MeshSat field kit V2, Option A(i) lid pack: sheet A1-1 arrangement B in plan: the lid module, the QMX set and every face part under the lid

MESHsat-1357, stream a1mech, 29 Sep 2026. Case frame: X east, Y toward the hinge (back) wall, Z up from the base floor, lid closed. mm. Prototype design, AI review: nothing built, bought or fitted; analytical success is not physical verification.

MeshSat field kit V2, Option A(i) lid pack: sheet A1-3 the arrangements that fit, and the owner decision

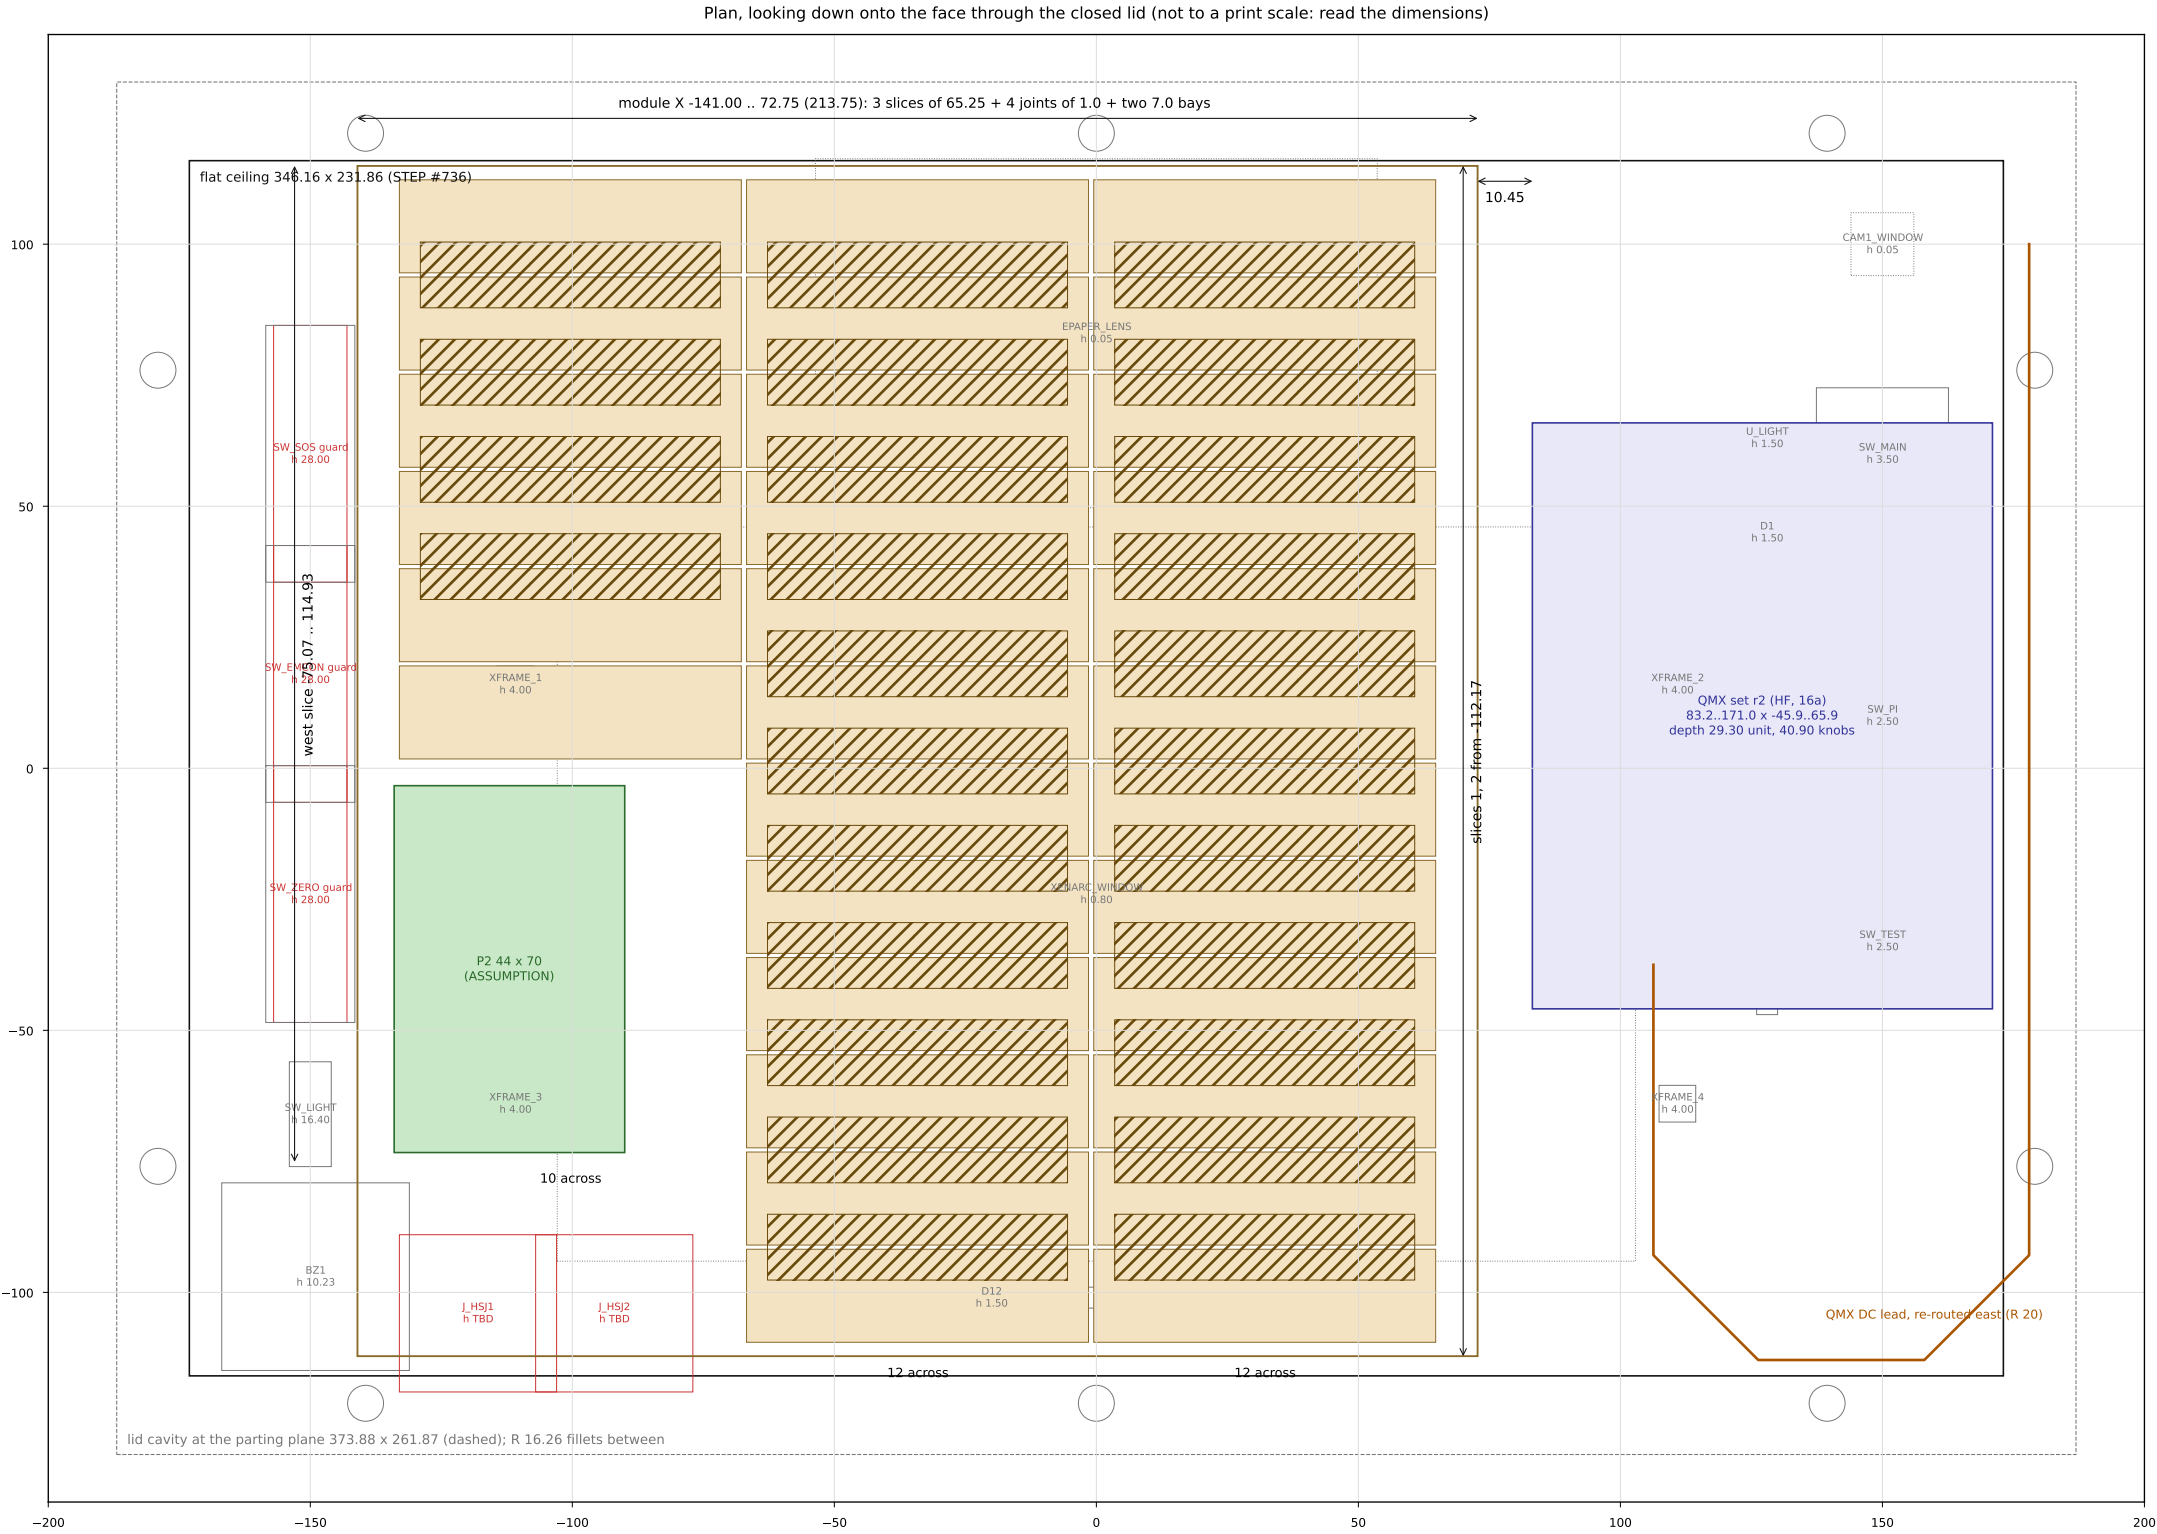
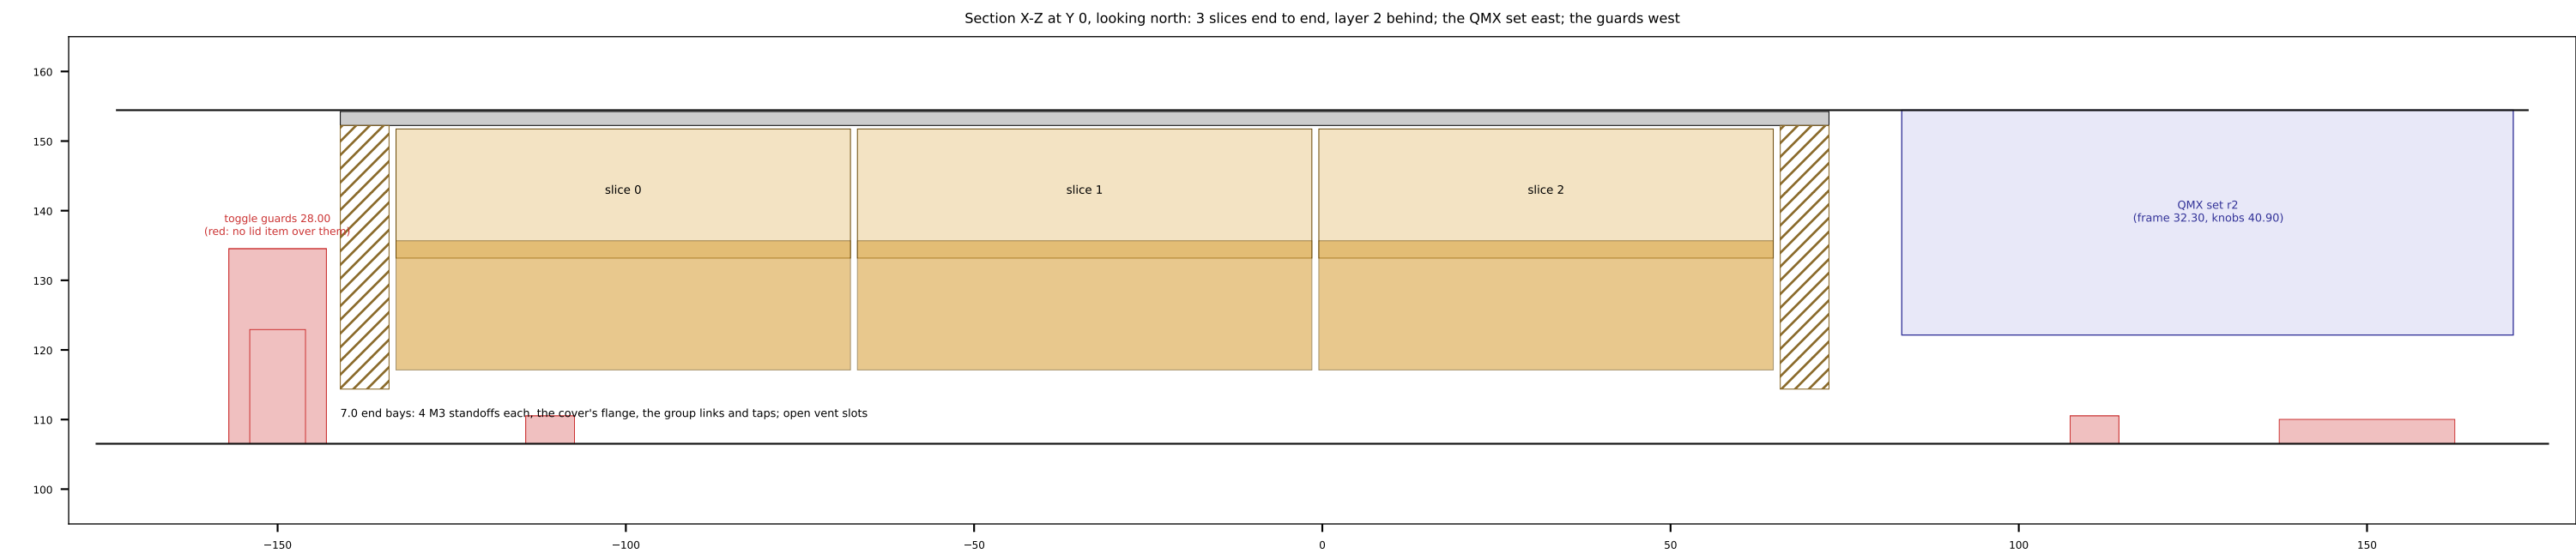
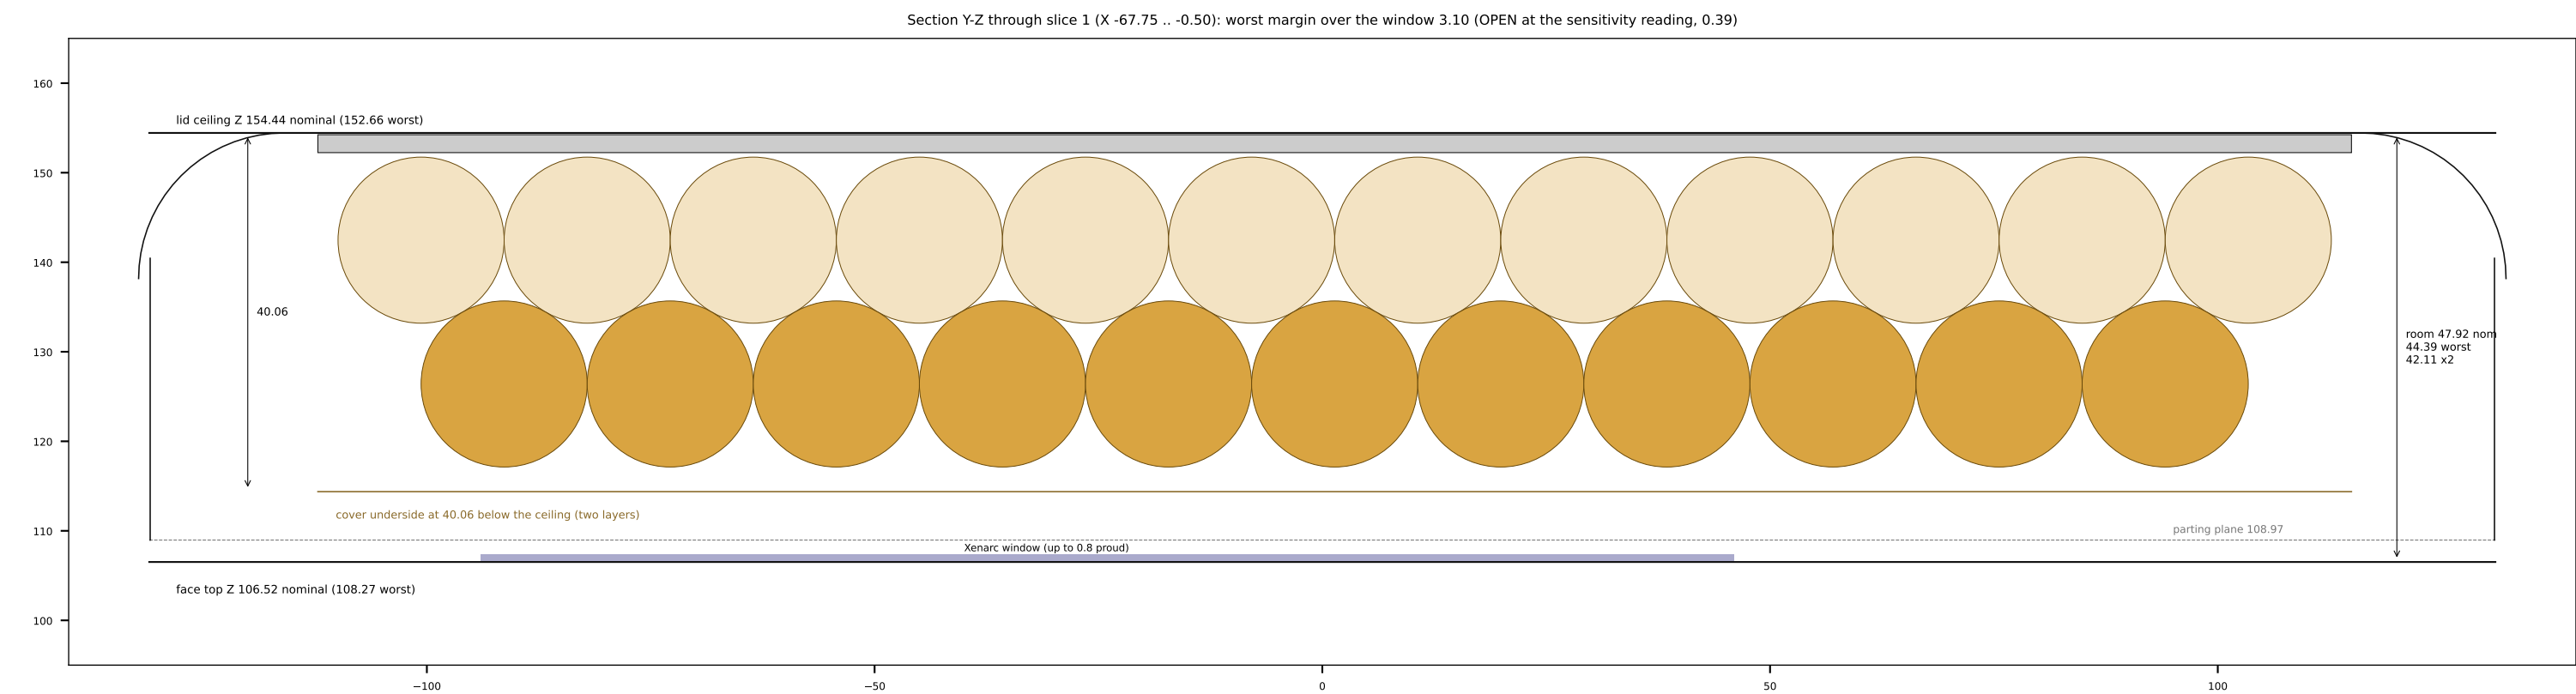
TIGHTEST ROWS (worst, x2; min 1.0)
two layers over the Xenarc window 0.80: 3.10, 0.39 OPEN
two layers over the LED bar 1.50: 2.40, -0.31 OPEN
two layers over the e-paper lens: 3.85, 1.14 MET
one layer over the XFRAME screws: 15.96, 13.25 MET
layer 2 refused over XFRAME_1 and _3 (4.00): -0.10 worst

PLAN module to the QMX tray 10.45; inside the flat ceiling
1.00 in Y (the fillets begin at +-115.93)
west edge 2.0 from the toggle guard caps (X -143.0)
west slice stops north of the headset jacks (TBD)

OPEN AT THE MOCK-UP: T9 (chalk on the module's cover and the
face parts, lid closed), T8 (pull test of a bonded plate on
Peli's polypropylene), T-A1-1 to T-A1-4 of the README.
